November 3, 2020

Re: Docket No. 72-1050; NRC-2016-0231; Federal Register v. 85, no. 90, Friday, May 8, 2020

Draft Environmental Impact Statement (DEIS) for Interim Storage Partners (ISP) Consolidated Interim Storage Facility (CISF) Project

Figure 1: Route considered by the ISP DEIS

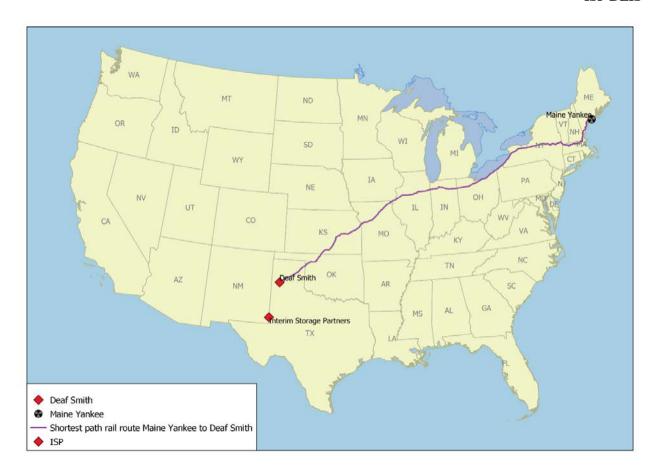
Another deficiency of the ISP DEIS's reliance on NUREG-2125 is that the affected radiological region of influence analyzed in NUREG-2125 does not reflect the likely shipment routes of the proposed action. In numerous EISs, DOE has identified the radiological region of influence (ROI) as an area extending 800 meters on either side of the centerline of the transportation route. DOE codified this approach in 2002 in *A Resource Handbook on DOE Transportation Risk Assessment*. Using this standard and the 2010 Census, there are more than 9 million people living within the ROI of the shortest path routes from US nuclear power plants to the proposed ISP CISF. <sup>10</sup> In contrast, there are only almost one million residents within the ROI along the route between Maine Yankee and Deaf Smith. <sup>11</sup> The ISP DEIS should recognize that all of the residents within the ROI are part of the affected environment created by the proposed action. The ISP DEIS's use of a single route from Main Yankee to Deaf Smith, TX as a template for environmental impacts is inadequate.

A comparison of the map of the single route used by NRC to scale-up its analysis for the entire program versus the map showing other possible rail routes to the facility reveals that the route chosen by NRC does not traverse states with similar rail characteristics. Thus, the route chosen does not provide a realistic appraisal of the impacts, since shipping routes have impacts that are highly specific to infrastructure, railroad transportation practices, and communities. Scaling up the impacts from a single route is inadequate to capture these unique, route-specific impacts.

The ISP DEIS was remiss in casually mentioning that the US Department of Energy or SNF title holders were responsible for the transportation of spent nuclear fuel to the proposed ISP CISF, then reporting that use of a single route from Main Yankee to Deaf Smith, TX should serve as a template for environmental impacts. Clearly, neither ISP nor the NRC chose to engage with the Association of American Railroads. If they had, the complexities of routing hazardous materials nationwide would have illuminated the oversight performed by the Federal Railroad Administration (FRA), the Pipeline and Hazardous Materials Safety Administration (PHMSA), and the Department of Homeland Security (DHS). The railroads have the responsibility to partner with local, state, and federal entities on hazardous materials-related issues,

In the final EIS, the NRC should not rely so heavily on the outdated NUREG-2125 and should provide a more realistic and thorough examination of the likely SNF transportation routes to the ISP CISF.
